SUBJECT: DIFFERING PROFESSIONAL VIEW (DPV) CONCERNING CONTAINMENT  
ISOLATION VALVES AT ZION

SUBJECT: COMMENTS ON A DPV CONCERNING EARLY BLOWDOWN CLADDING  
RUPTURE DURING A LARGE BREAK LOCA

Comments on a DPV Concerning Early Blowdown  
Cladding Rupture During a Large Break LOCA

FIGURE 1. Nominal CSAU Case

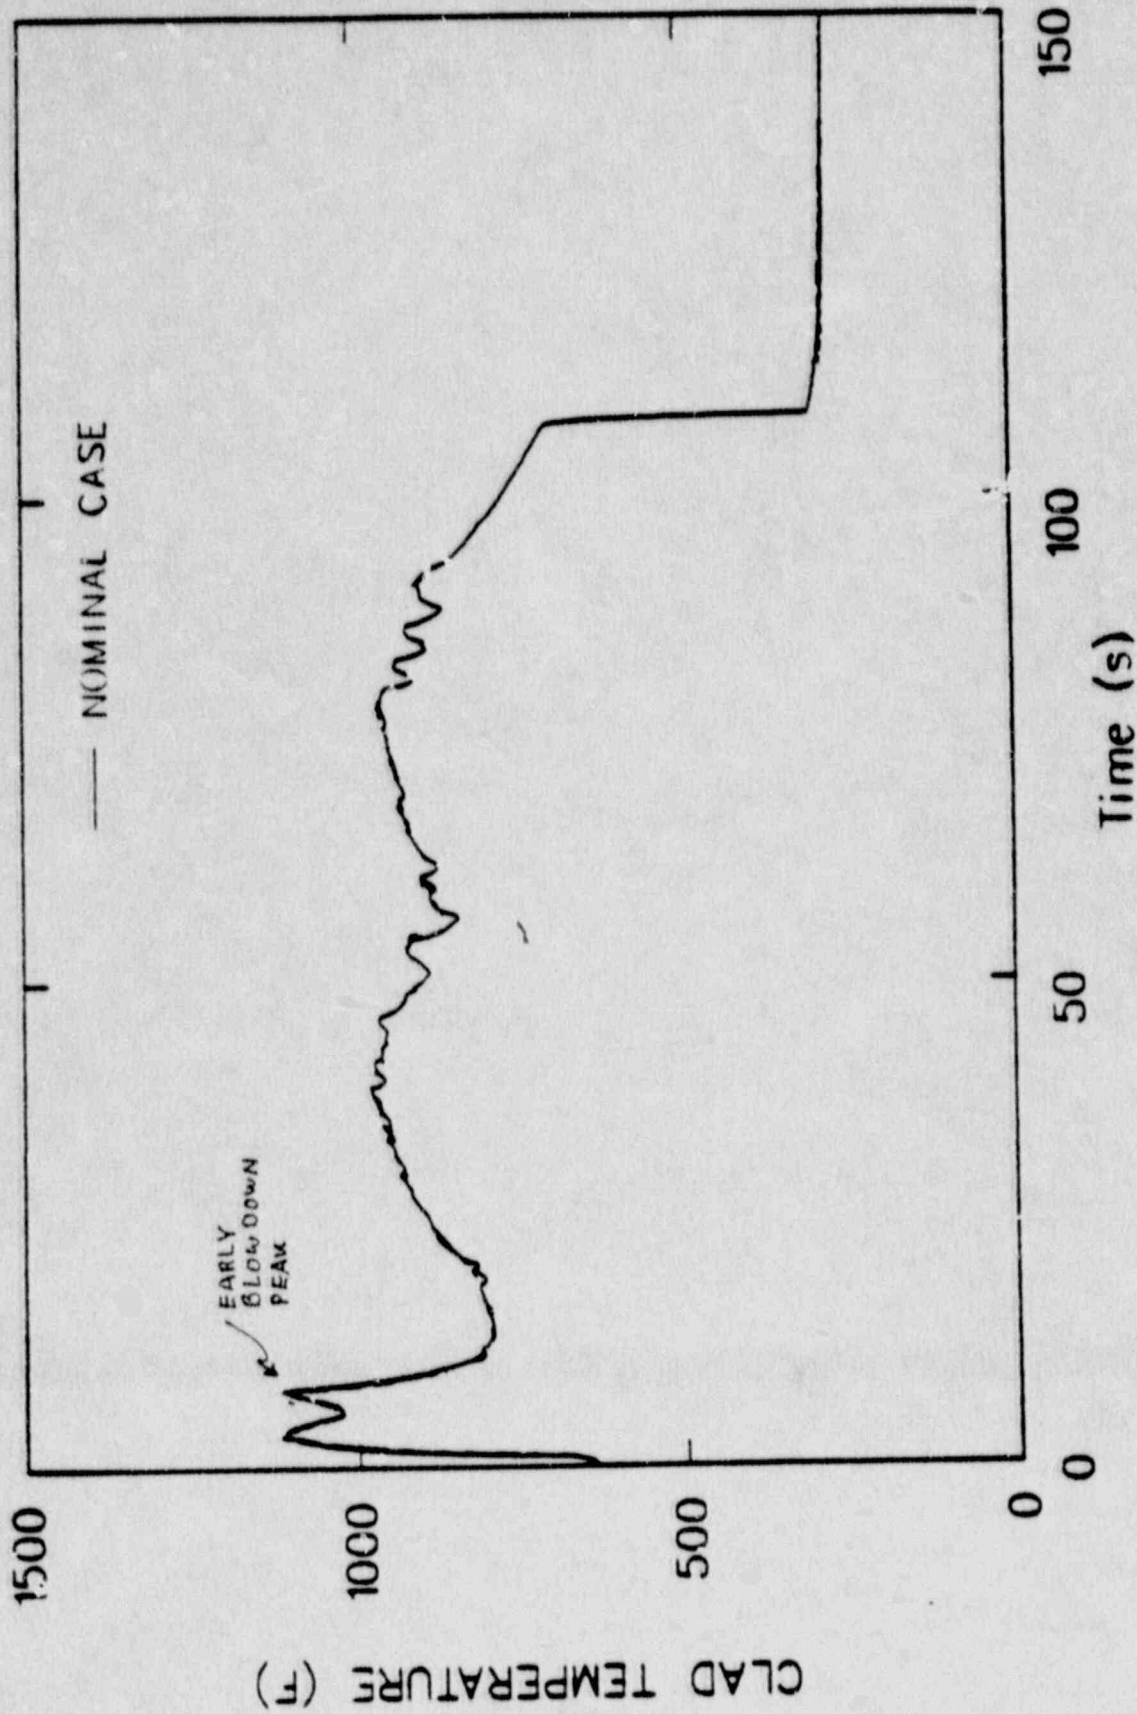
Issue 2 (p. 3-2) - "This shows that on infringement of DNBR at 1/10 second, average clad temperature increase very rapidly from a normal operating value of 720°F to at least 1350°F, and then to 1750°F, over a total period of seven seconds."

1750°F is indeed a very high early blowdown peak cladding temperature (PCT), but virtually impossible for a high burnup pin with a much lower PLHGR. If a high burnup pin reached 1750°F, at 7 seconds it would most likely rupture. More realistic LOCA analyses have been performed as part of the Code Scaling, Applicability, and Uncertainty program in RES. A best estimate analysis was performed and code uncertainties evaluated for a large break LOCA (Reference 2). In order to accomplish this, sensitivity studies were performed which varied gap conductance, peaking factors, and several other variables. The plant used was a Westinghouse 4-loop 3411 MWt plant with 17x17 fuel and a low burnup of only 16000 MWD/MTU which resulted in a PLHGR of 9.35 kw/ft. The blowdown peak for the nominal CSAU case was 1103°F (see Figure 1). Based on over 250 clad temperature calculations and using Monte Carlo sampling techniques, it was determined that the 95th percentile blowdown PCT was 1447°F. It has been determined that 15x15 pins (as used at Zion) with burnups greater than 40,000 MWD/MTU have PLHGRs no greater than 6.4 kw/ft. Using the CSAU calculated sensitivity of blowdown PCT to LHGR, the value of 1447°F can be extrapolated to approximately 1320°F for the 6.4 kw/ft PLHGR high burnup 15x15 pin. This illustrates that the 1750°F blowdown PCT calculated by Westinghouse is quite conservative, especially for a high burnup pin. I believe that this Westinghouse calculation is probably at least 10 years old.

Figure 2. Comparison of measured and calculated fuel rod plenum pressure versus time for Rod 3 of PBF test LOC-3.

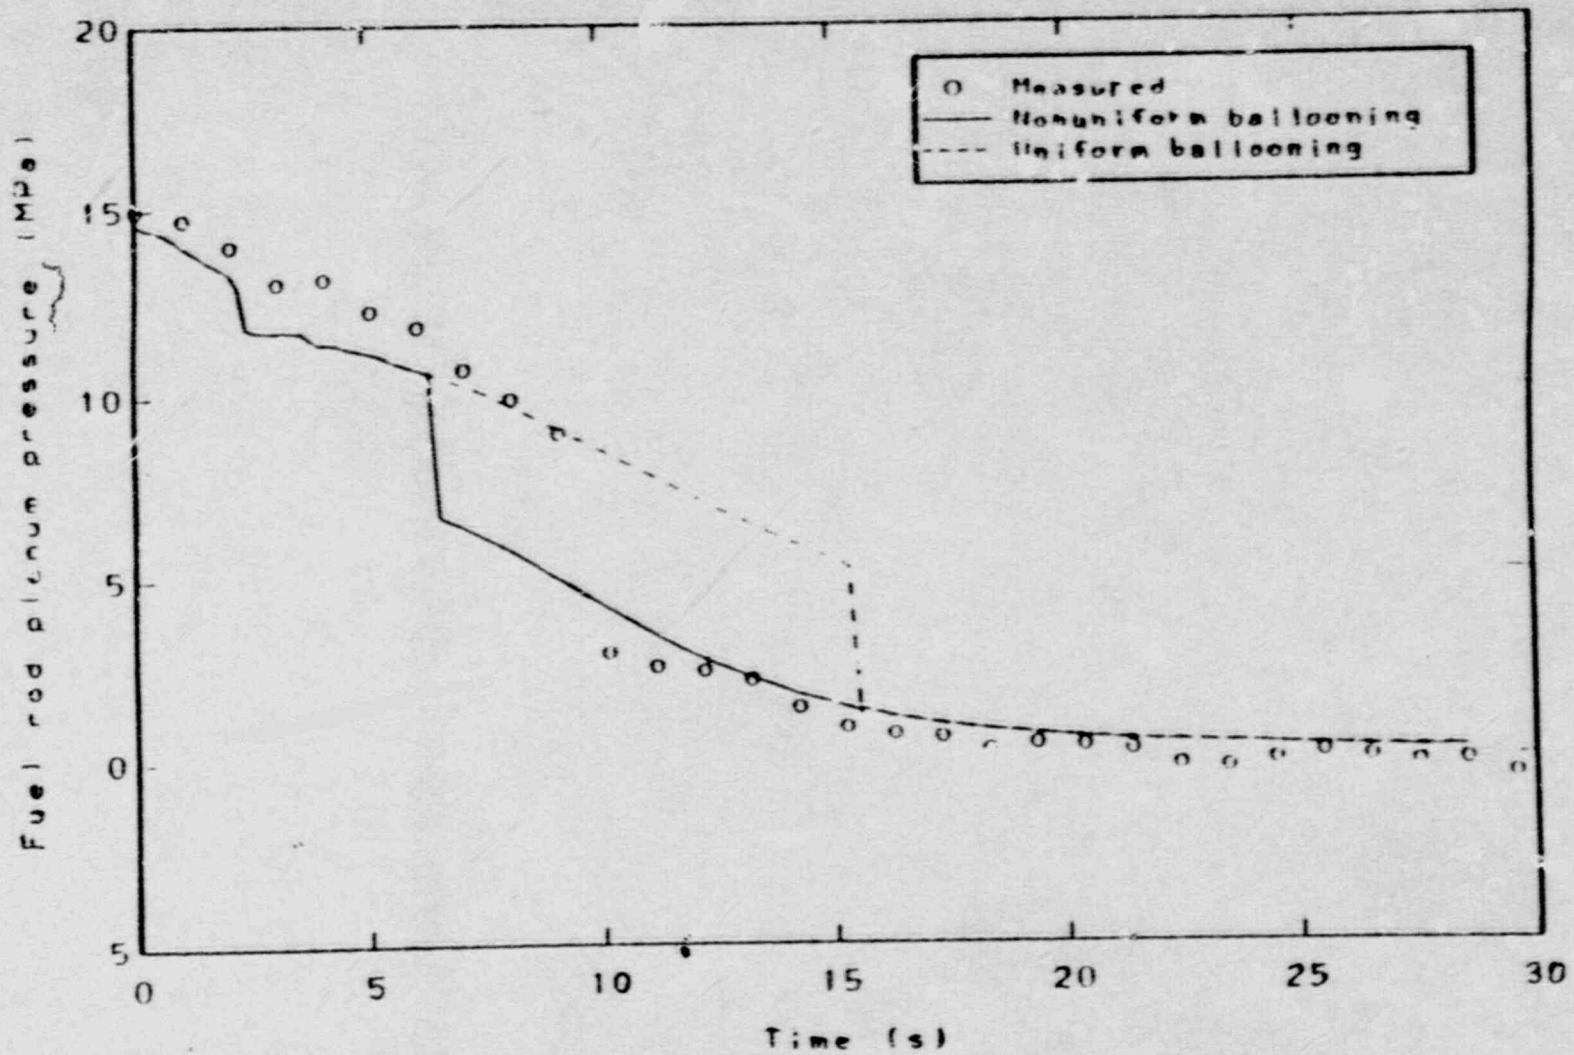
Issue 6 (p. 3-3) - "It is proposed that, immediately, on a LOCA as clad temperature increases to 1350°F, gap pressure will increase by 20%, to 1800 psig .... At 7 seconds into the event, clad temperature has increased further to 1750°F, .... From this, it can be proposed that gap pressure for the complete rod can increase by 36% over its normal operating value to 2100 psig."

The basis for concluding that pin pressure increases during an LBLOCA blowdown is not known and contrary to the evidence. A series of 3 large break LOCA simulations (Reference 3) (LOC-3, LOC-5, and LOC-6) were performed in PBF with well instrumented Zircaloy clad UO<sub>2</sub> fuel elements pre-pressurized to simulate low and high burnup PWR fuel. PBF blowdowns are quite severe compared to postulated PWR LBLOCA blowdowns. In PBF, the pressure decrease and rate of mass loss is very rapid. No good reverse flow blowdown heat transfer is evident as is the case in LOFT results or PWR analysis. Figure 2 (Reference 6) shows the fuel rod pressure for rod 3 in test LOC-3. Also, shown are FRAP-T6 calculations using two different plastic deformation models. Clearly, pressure decreases throughout the transient. Figure 3 is a plot showing measured pressure decrease for Rod 11 in Test LOC-6. A FRAP-T6 characterization calculation was done for a postulated LBLOCA in Zion (reference 7) which also showed a pressure decrease throughout the transient.

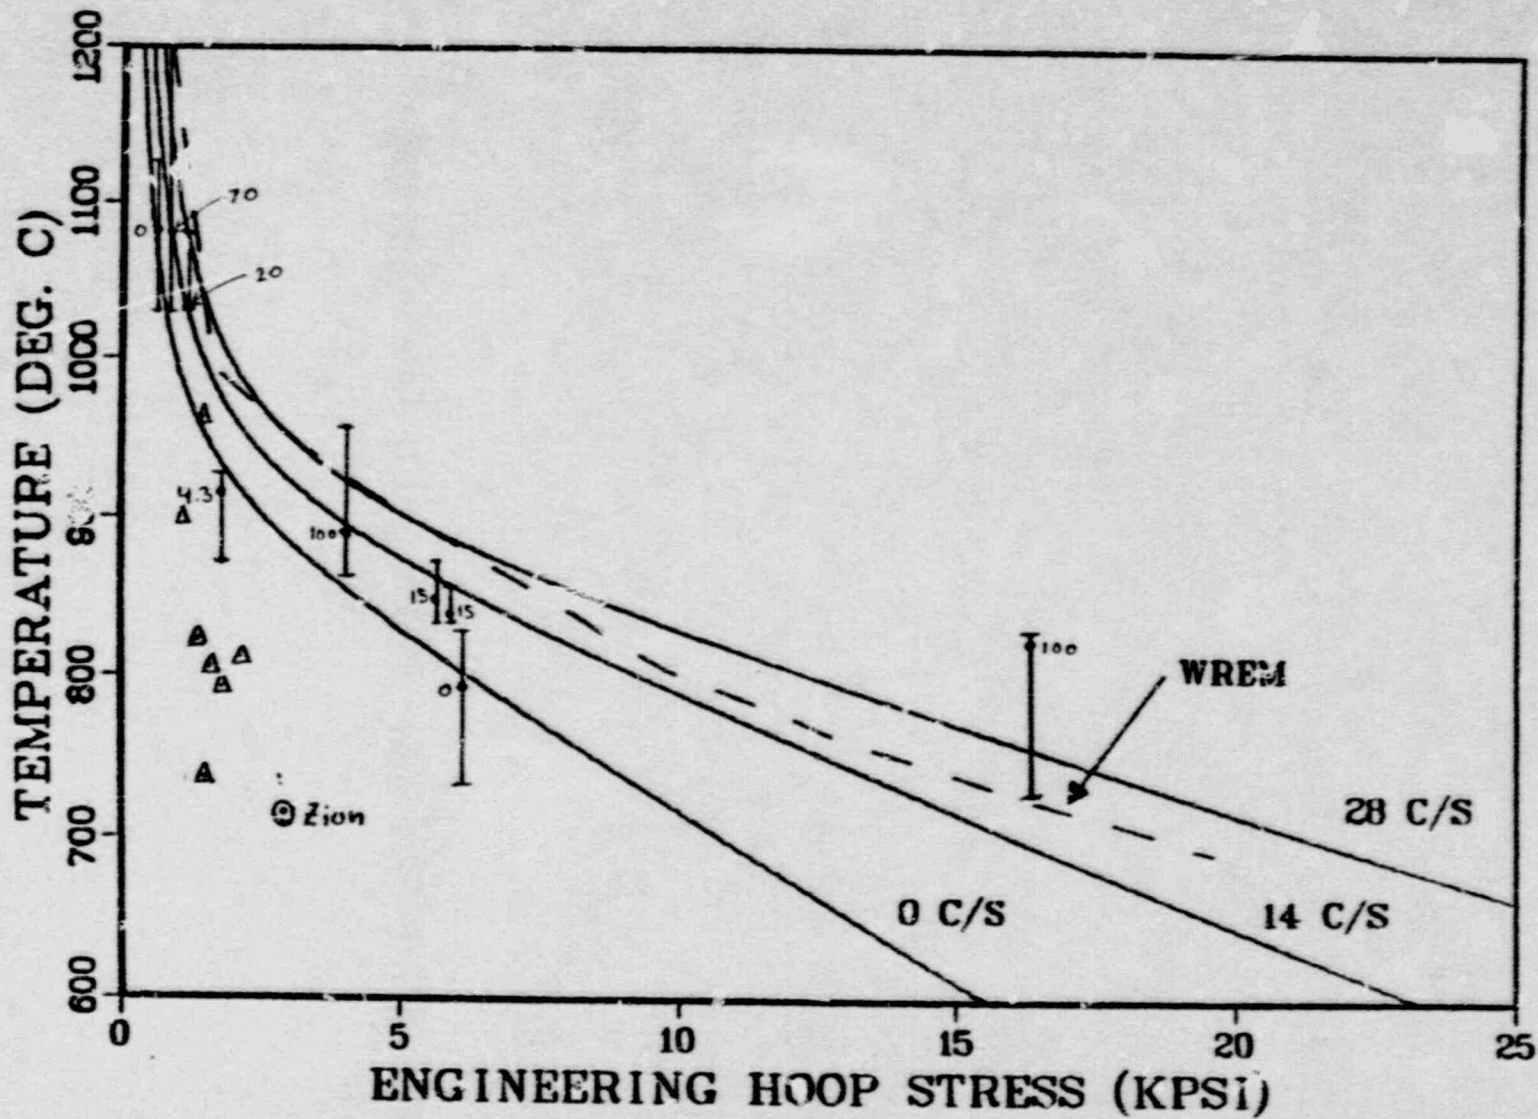
Issue 7 (p. 3-5) - Concern is expressed about the relevance of electrically heated rods used in defining the swelling and rupture curves in NUREG-0630. It is suggested that the TREAT data shown in NUREG-0630 (Reference 6) would be more realistic. Also, on pp. 4-3 and 4-4, this concern is restated.

It is clear that TREAT data is anomalous compared to the electrically heated rods and is attributed to difficulties in obtaining accurate temperature data in the burst region. A better source of in-reactor data is the PBF series discussed previously. Figure 4 is a plot from NUREG-0630 (Reference 8, Exhibit 16). Included are data points with temperature uncertainty for the 9 ruptured rods in the PBF LOC series of tests, and the FRF data from TREAT. It is clear that the more recent PBF data is very consistent with the NUREG-0630 curves.
